**CITY OF MERIDIAN
FINDINGS OF FACT, CONCLUSIONS OF LAW
AND DECISION & ORDER**

In the Matter of the Request for Preliminary plat (PP) Consisting of 25 Buildable Lots on 36+/- Acres of Land in the R-40 and C-C Zoning Districts for Outer Banks Subdivision; and a Conditional use permit (CUP) for a Multi-Family Development Containing a Total of 516 Residential Dwelling Units Consisting of (364) High-Density Apartments, (126) Flat and (26) Townhome Style Units in the R-40 and C-C Zoning Districts for The 10 Meridian, by JUB Engineers, Inc.

Case No(s). H-2021-0063

SUBJECT: H-2021-0063 – Outer Banks Subdivision/The 10 Meridian

C. Landscape Plan for Preliminary Plat (dated: ~~9/16/24~~ 12/6/2021) – REVISED

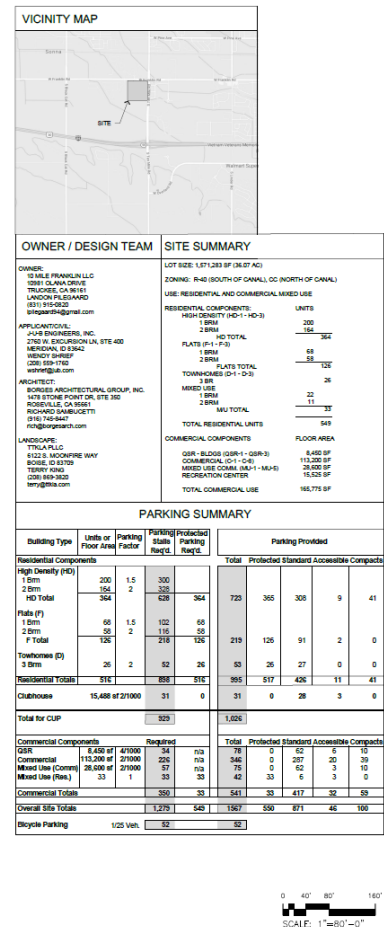
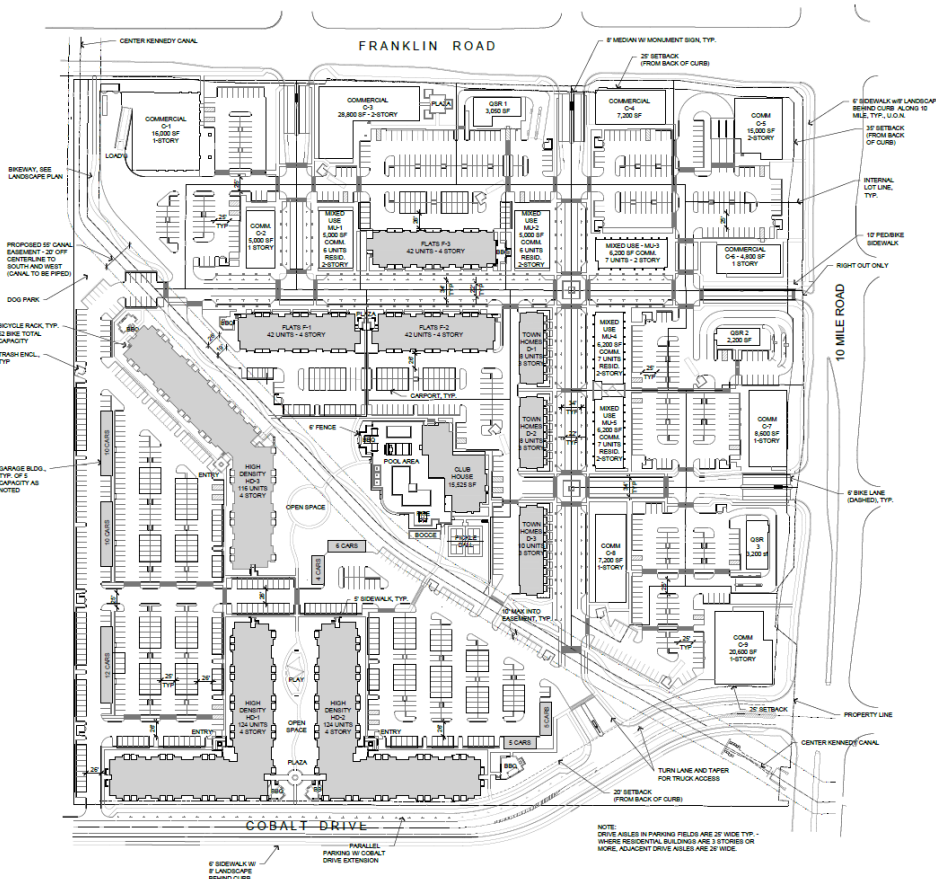
3. The landscape plan included in Section VIII.C shall be revised as follows:
 - a. Include shrubs (along with the trees and lawn or other vegetative groundcover) in the proposed street buffers as set forth in UDC [11-3B-7C.3a](#) and along pathways as set forth in UDC [11-3B-12C.2](#).

- c. Include a calculations table on the landscape plan that demonstrates compliance with the landscape standards for street buffers listed in UDC [11-3B-7C.3b](#); common open space areas listed in UDC [11-3G-3E.2](#); and pathways listed in UDC [11-3B-12C](#).

D. Site Plan for Multi-Family Portion of Development (date: ~~8/23/2021~~ 12/03/2021) - REVISED

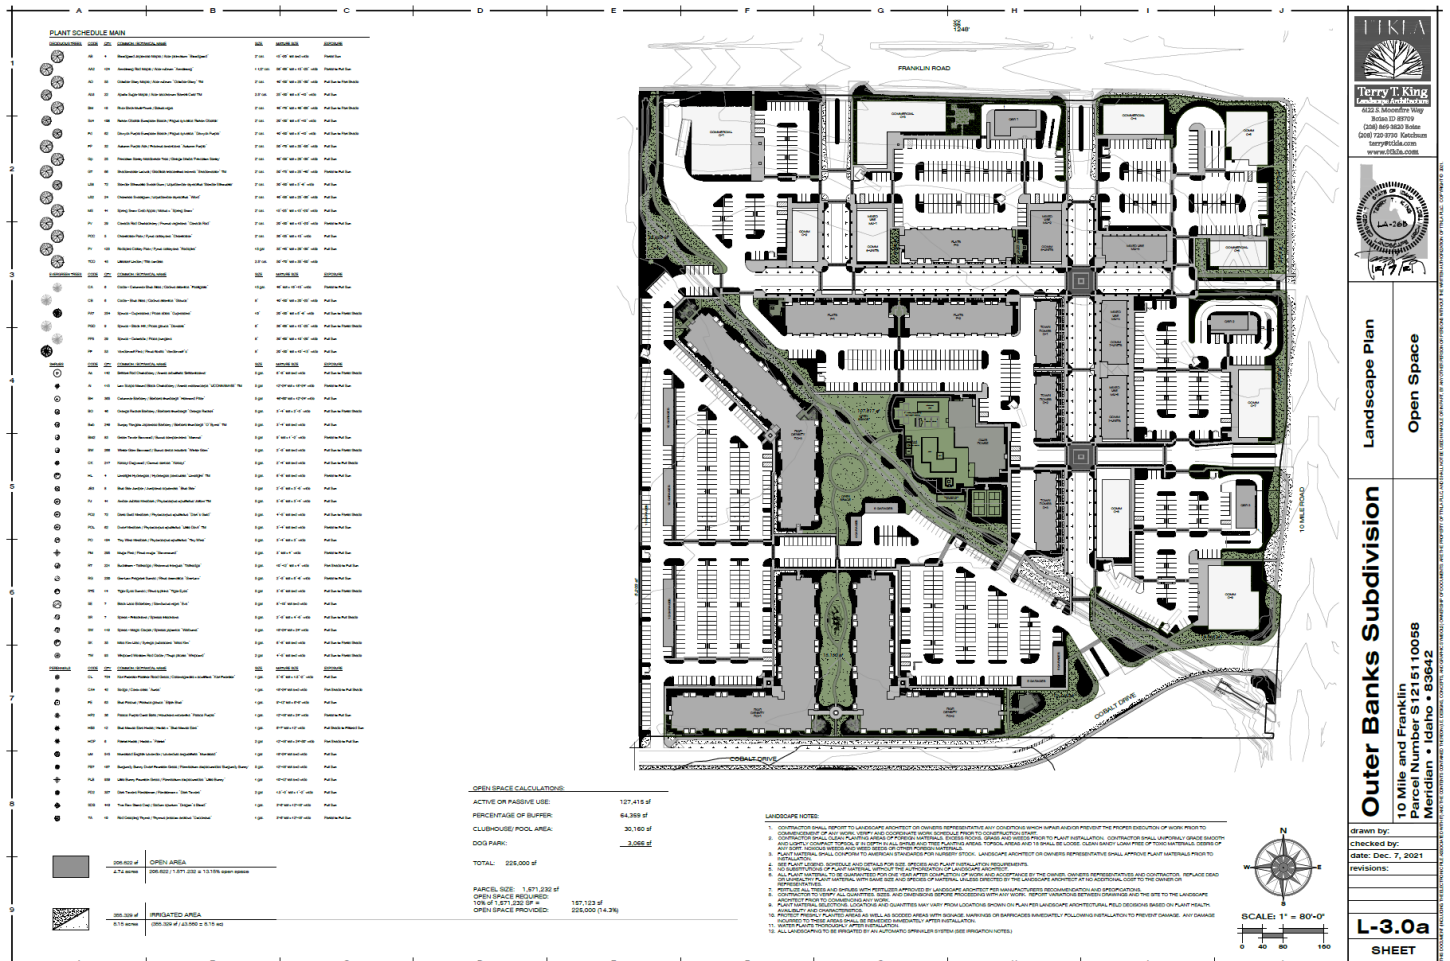
- b. Depict the locations of the property management office, maintenance storage area, central mailbox location (including provisions for parcel mail, that provide safe pedestrian and/or vehicular access), and a directory and map of the development at an entrance or convenient location for those entering the development in accord with UDC 11-4-3-27B.7.

- d. The configuration/location of the Flats F-3 building and the ~~garage carport~~ structures along the project's west boundary need to be revised to comply with the minimum setback requirement of 10-feet in UDC [11-4-3-27B.1](#); the configuration of Lot 16 may be revised on the plat in order for the building (i.e. F-3) to meet the required setback.

- f. Include a detail of the fire pit, BBQ's, public art and children's play structure.
 - g. A minimum of ~~902~~ 995 off-street parking spaces shall be provided as proposed, including ~~530~~ 517 covered spaces. Compact stalls are discouraged but may be used for any parking above the number of required spaces per UDC [11-3C-5A.6](#). *This does not include the 31 spaces required for the clubhouse, vertically integrated/mixed use or commercial uses.*
